## 263C Cellular Communicator November 2015

### Hardware Update

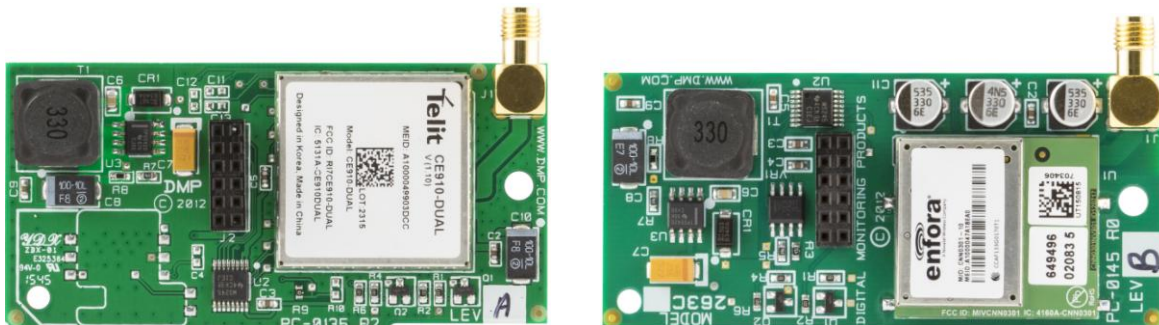
As of November 9, 2015 the 263C Cellular Communication Module is being manufactured using a Telit CDMA modem. The updated 263C with the Telit modem will begin shipping as existing 263C inventories are depleted approximately the week of December 7th. The Model 263C/381-2 began shipping with the Telit modem as of November 17th.

The Telit CDMA modem is replacing the current Enfora CDMA modem but with no differences in modem operation. The Telit modem and Enfora modem are both fully supported by SecureCom Wireless services.

The newer Telit 263C modules will be built on the PC-0135 printed circuit board as level A hardware. The Enfora 263C was built on the PC-0145 Level B PCB.

The following DMP panel firmware updates are necessary when using the 263C Telit modem. The firmware updates provide operation for both the Telit and Enfora modems.

- XT30/XT50 Firmware Version 123 (6/10/15) or higher which was released on 6/15/2015.
- XR150/XR350/XR550 Firmware Version 109 (8/18/15) or higher which was released on 8/31/2015.
